**WHITE LAKE TOWNSHIP
INTER-OFFICE MEMORANDUM
COMMUNITY DEVELOPMENT DEPARTMENT**

SUBJECT: 9101 Highland Rezoning Request

RE: 9101 Highland Road-Proposed Commercial Development- Preliminary Site Plan Review – 3rd Review

Our office has performed a Preliminary Site Plan review for the above-mentioned revised plan dated December 20, 2024. The plans were reviewed for feasibility based on general conformance with the Township Engineering Design Standards.

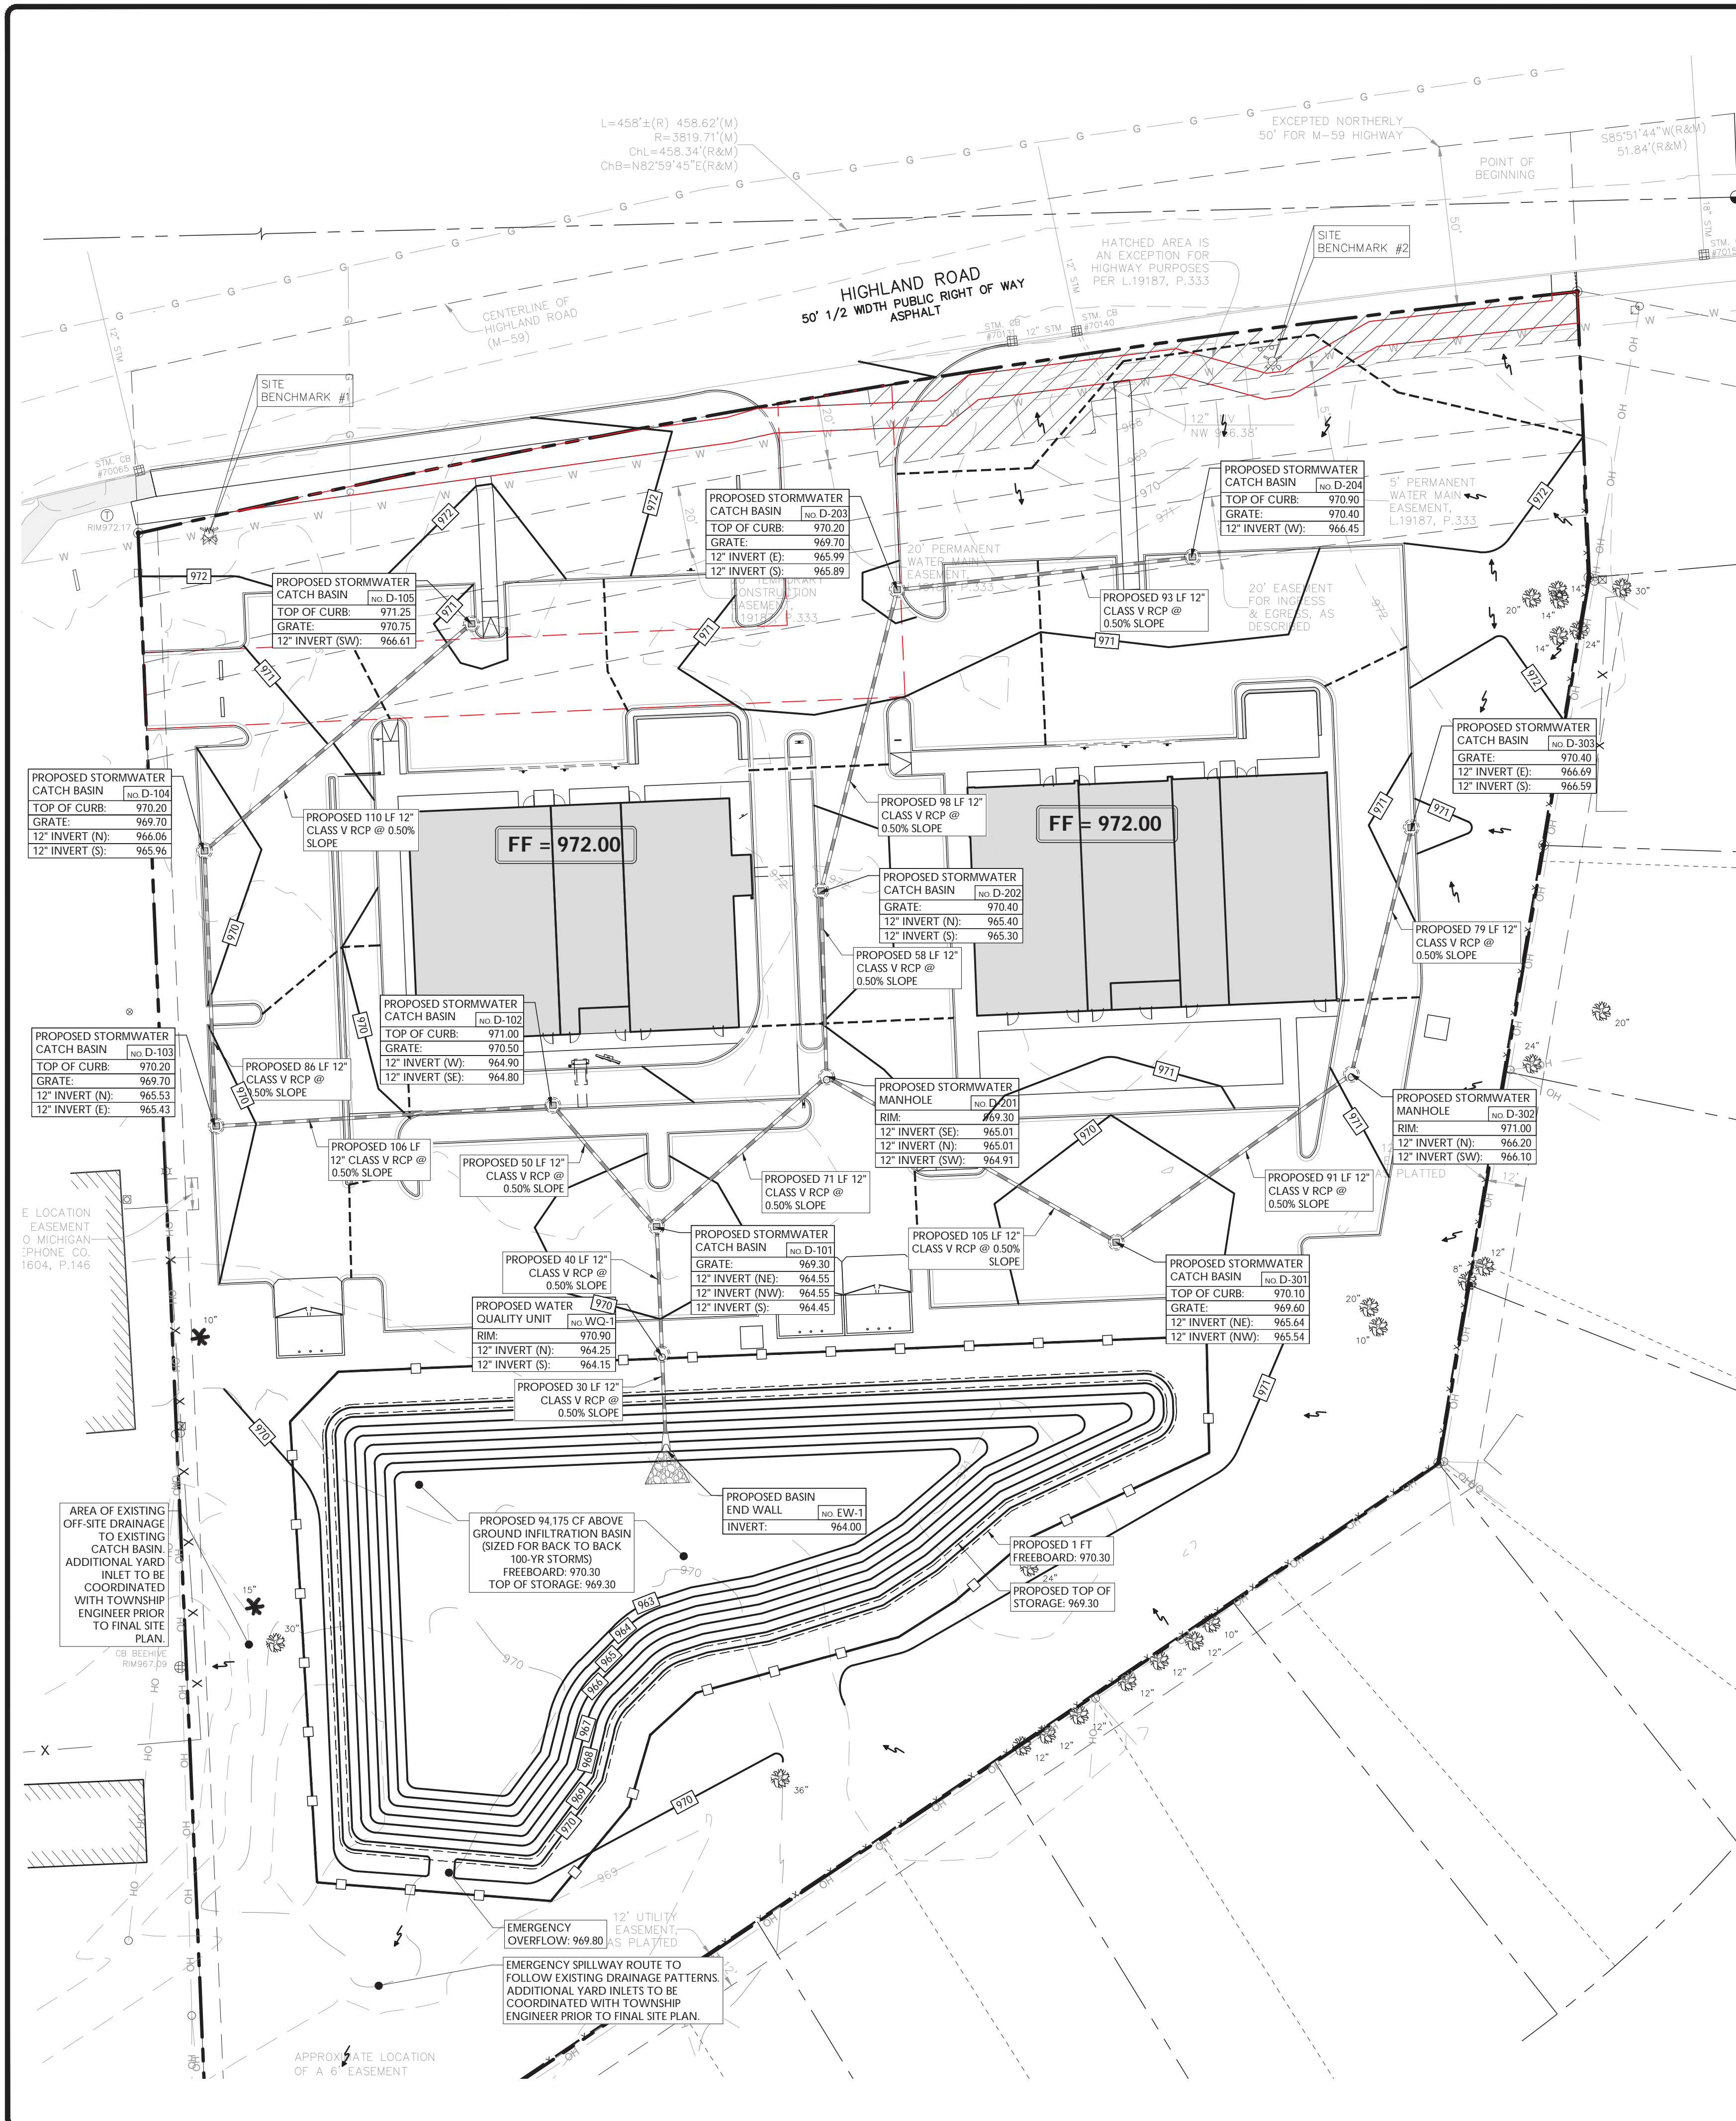
- d) *Sheet C-3-The existing sidewalk along M-59 appears to be in disrepair. In addition, the sidewalk does not meet the requirements of the current Township Zoning Ordinance Sections 5.20 and 5.21 in terms of required clear zones. We defer to the Township as to whether a new sidewalk meeting the Zoning Ordinance shall be required. Comment partially addressed and remains. A new 8' wide asphalt pathway is now proposed. The proposed pathway location continues to not meet the required clear zone dimensions. We continue to defer to the Township regarding the inadequacy of the required clear zones. In addition, a portion of the proposed pathway is now shown in a proposed sidewalk easement. The sidewalk easement exhibit(s) will be required to be reviewed by our office prior to execution and recording of the easement. **The proposed pathway now appears to conform with the required clear zone dimensions as outlined in Township Zoning Ordinance 5.20. We consider the portion of the above comment regarding this to be addressed. The portion of the above comment referencing the sidewalk easement remains.***

- e) *Sheet C-3-There is a recorded temporary construction easement shown. Please indicate if this easement has been vacated. If the easement has not been vacated, it shall be required to be vacated prior to FSP/FEP approval. **Comment remains. Design engineer states that they will coordinate vacation of the easement with the Township prior to FSP/FEP submittal.***

Sheet C-3 indicates the applicant is requesting a waiver for site access. We note later in this review that the Planning Commission may waive this requirement per certain criteria.

Proposed building envelopes and setback standards are shown on Sheet C-3 as well as district bulk and lot regulations. Standard bulk and lot regulations for the RB zoning district are set forth in Section 3.1.14.

Sheet C-3 shows a proposed stub access drive at the west end of the property. A note indicates the drive is a proposed twenty-four (24) foot access drive and easement to be stubbed at the property line. The aerial image below shows the neighboring site to the west does not currently have a stub to the subject property. The neighboring property does share an internal drive with the adjacent property to the west. The applicant indicates the stub road will be connected to the neighboring site when that site is redeveloped. Concrete parking blocks are shown to detour vehicles from entering the temporary stub.

Section 5.11 outlines requirements for off-street parking. Sheet C-3 provides parking locations and calculations for the various retail and restaurant functions anticipated for the site. Parking is placed predominantly around the periphery of the two buildings with a limited number of spaces located between the structures. Parking lot and drive aisles will be constructed of asphalt. Concrete is proposed for limited portions of the drive thru and dumpster pads.

Sheet C-3 shows a six (6) foot high vinyl fence around the detention basin. Per landscaping buffer requirements between specific zones, an eight (8) foot obscuring fence is proposed along the eastern and southern lot lines where the property abuts residential districts. Specification of screening materials are required for final site plan.

DRAWING: C-7

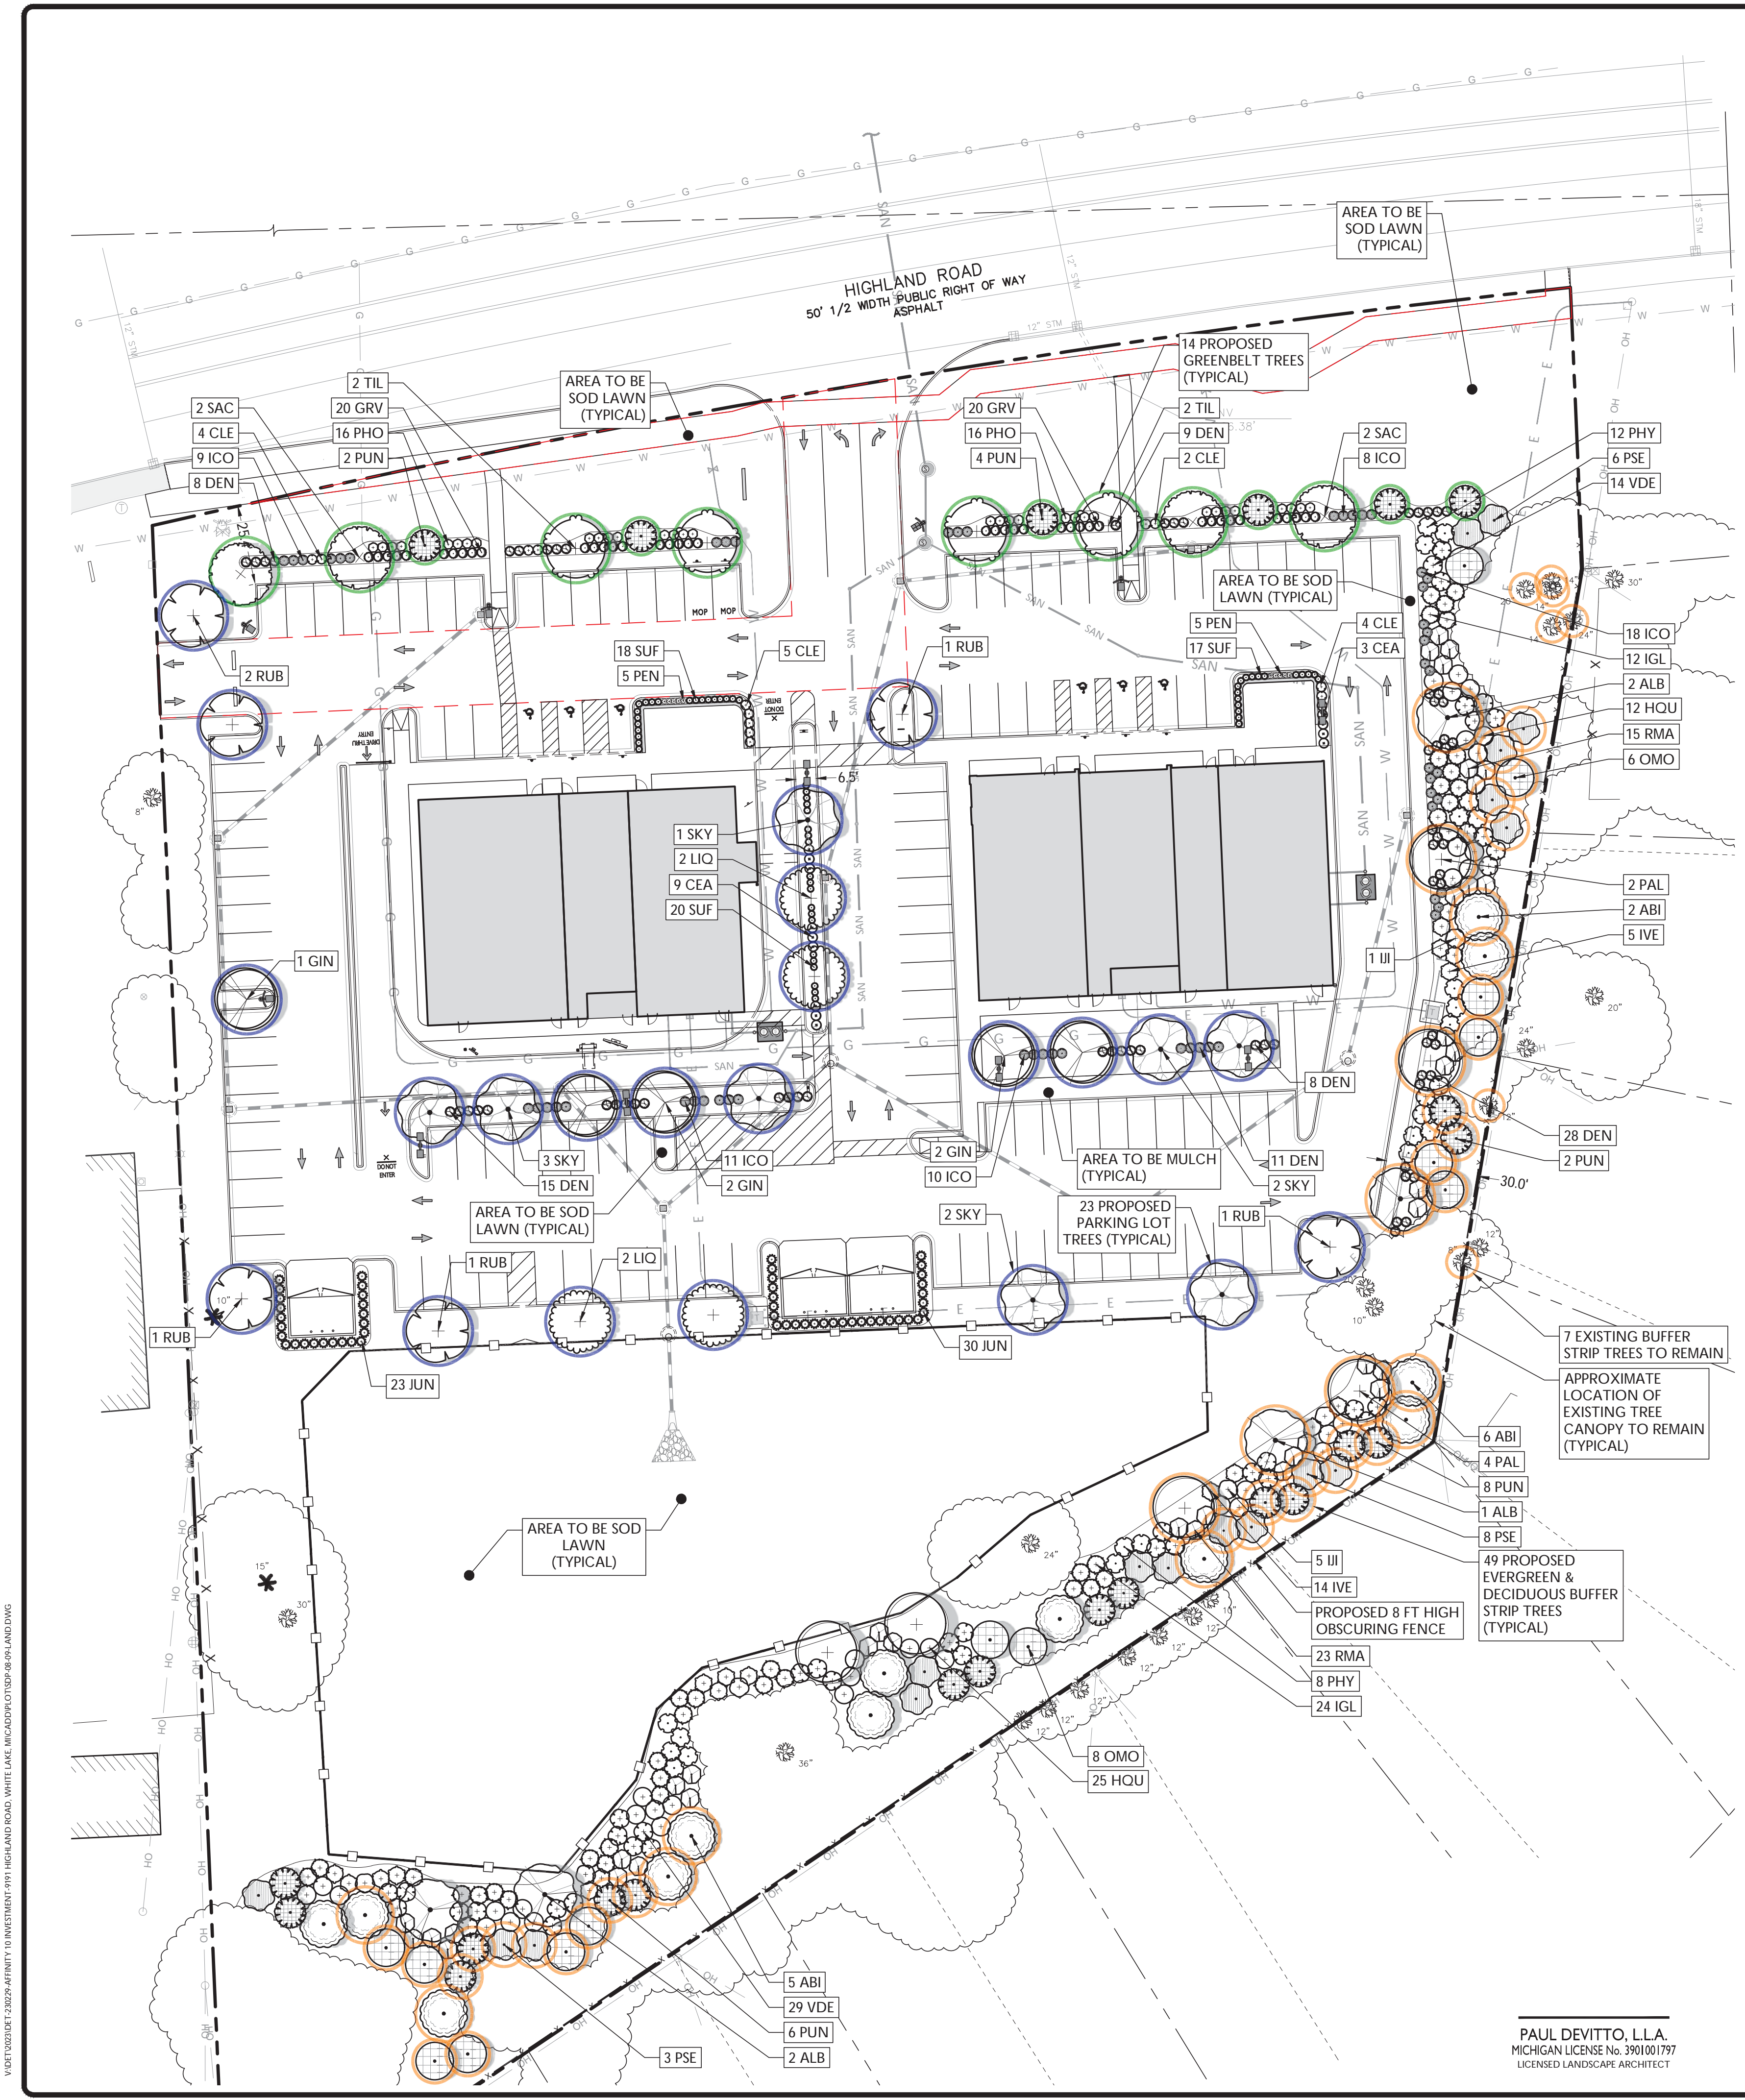
Given the site will have multiple tenants, Sheet C-7 should have a note stating that there shall be no flashing, oscillating, moving or intermittent type of lighting or illumination on the site.

Items to be Addressed: Sheet C-7 should have a note stating that there shall be no flashing, oscillating, moving or intermittent type of lighting or illumination on the site

SCALE: 1" = 30' PROJECT ID: DET-230229
TITLE:
LANDSCAPING PLAN
DRAWING:
C-8

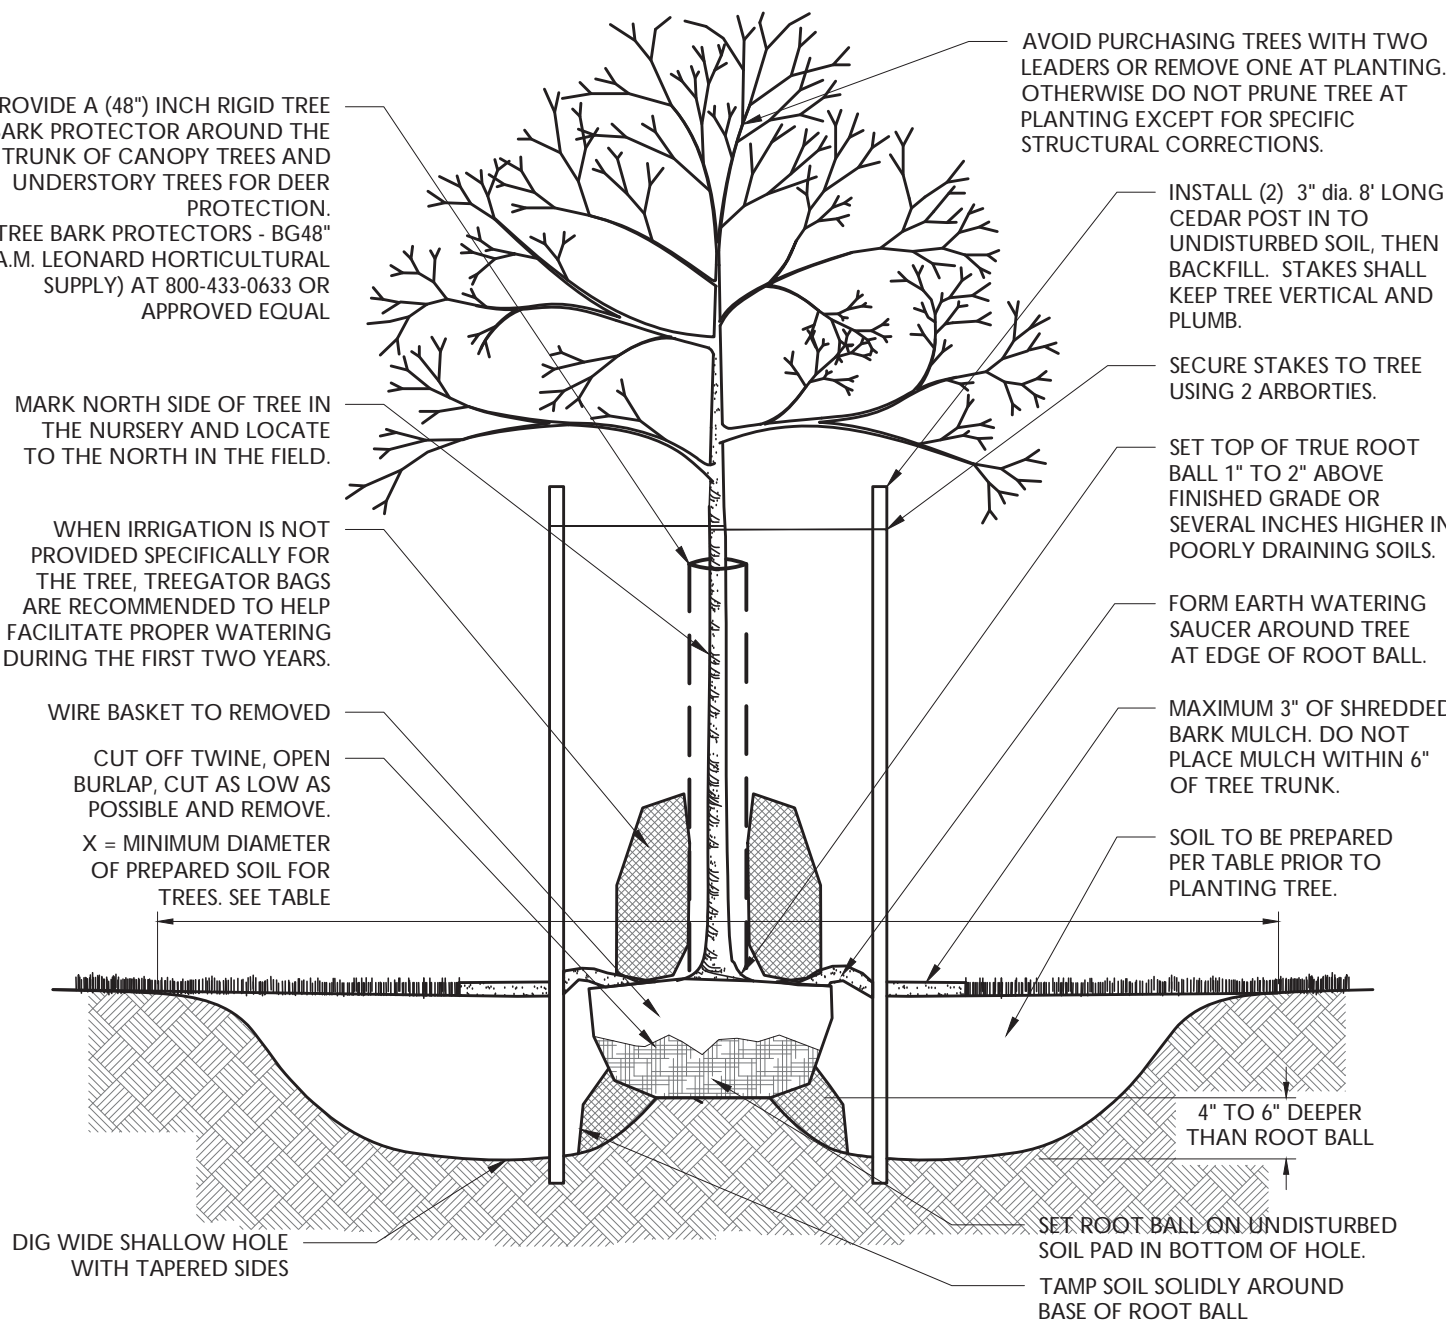
- p) *Sheet C-8- There is an existing tree that is shown to remain in the area of the proposed retention basin. Tree will likely be required to be removed, or basin location revised so as to avoid tree In basin.*
Comment partially addressed. Existing tree within the basin shall be removed per the design engineer; however, please cross out this tree on Sheet C-2.
- q) Sheet C-3-Proposed pedestrian access sidewalk from M-59 path to the eastern building-Show crosswalk hatching/stripping across internal traffic circulation lane. This item can be addressed on the FSP/FEP.

Landscape and screening information is required at final site plan review. The applicant has provided a detailed landscape plan on Sheet C-8. Per this information, we will provide a full review of the landscape plan. Any deficiencies noted should be addressed at final site plan review.

Items to be Addressed: 1.) Dimensions between trees and property lines should be included on Sheet C-8 and conform to the four (4) foot setback requirement. 2.) The applicant should remove the trash enclosure detail from Sheet C-13 and clarify the CMU enclosure wall decorative feature on Sheet A-302 for final site plan. 3.) Specification of screening materials proposed for the eight (8) foot property line fence are required for final site plan.
